Chemtura Corporation
Global Registration Chemistry
199 Benson Road
Middlebury, CT 06749-0001

Re: NRC License No. 06-00221-08, Docket Number: 030-03759

Subject: Decommissioning of Bethany, Connecticut Site Only

Pursuant to your request for additional information regarding our request to amend Nuclear Regulatory Commission License No. 06-00221-08 we are making the following changes in the "Proposed Sampling Plan for Final Radiological Status" dated June 11, 2010. The numbered responses below coincide with those in your letter dated July 15, 2010.

CORRAL

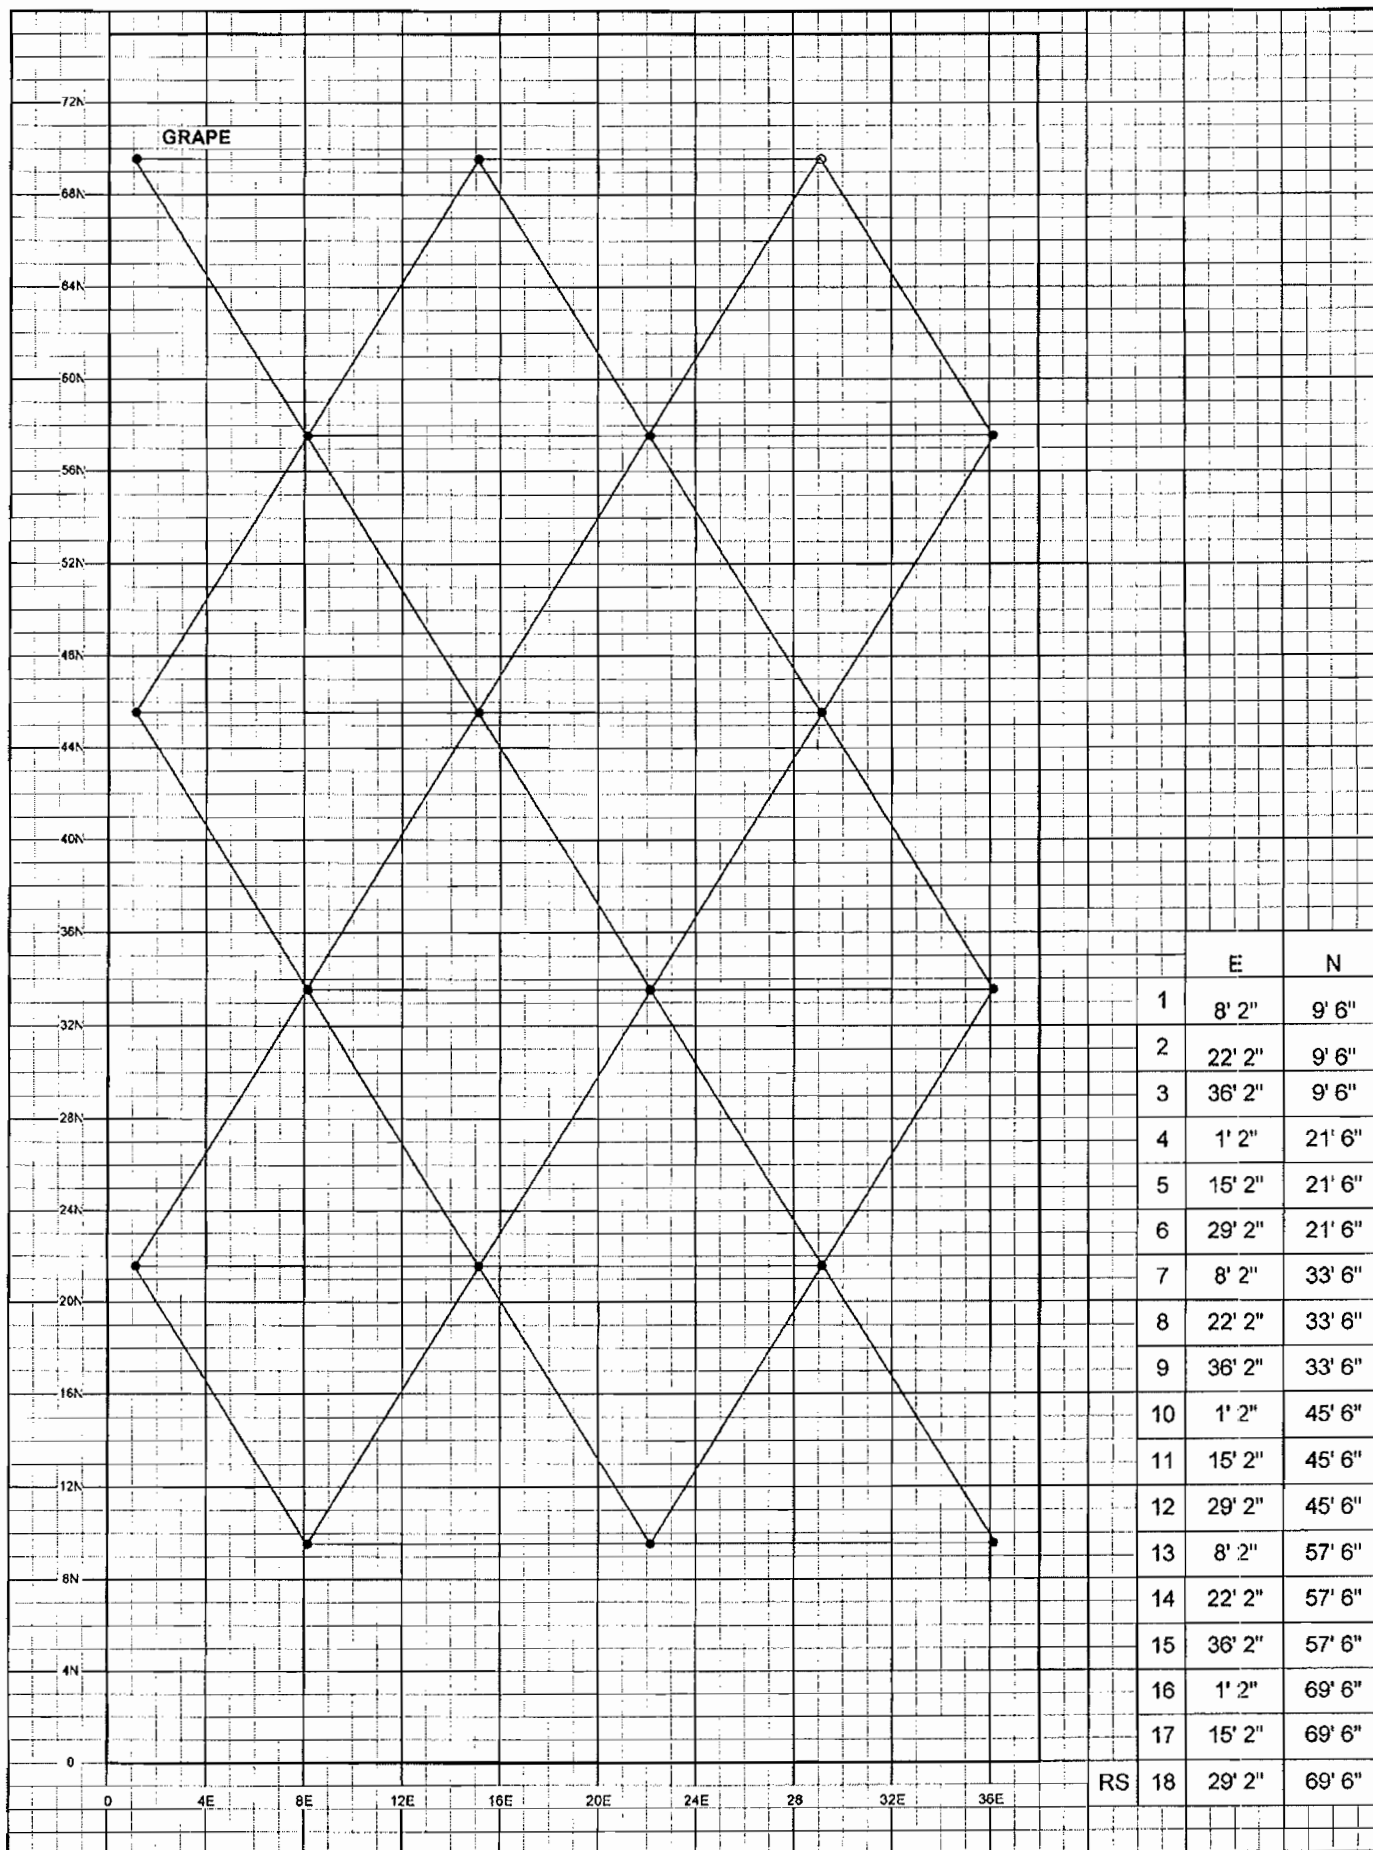
1, 2. Based on a conversation on 29 July 2010 between you and Jay R. Dockendorff of Radiation Safety Associates, Inc. we are making the assumption that background contribution from Carbon 14 will be zero.

As a result, we are abandoning the use of the Wilcoxon Rank Sum statistical test and will instead be using the Sign Test. We will assume that any Carbon 14 found in the samples is due to licensed activity. Additionally, we will remediate the individual survey unit areas if any single test result exceeds the site specific and State of Connecticut mandated DCGL of 9.12 pCi/g. Following any additional remediation a new random start point will be selected and a new triangular grid sampling pattern will be established. We do not plan to do double-sampling or two-stage sampling.

The number of samples required under the Sign test was recalculated with a resultant sample count of 18 samples per survey unit. A new triangular grid has been established for each survey unit based on the increased number of sampling points required. For the "corral", "grape" and "apple" survey units the same random start point was utilized to calculate the new sampling grid. For the "peach" survey unit a new random starting point was generated to establish the sampling grid. The up-dated sampling maps are attached.
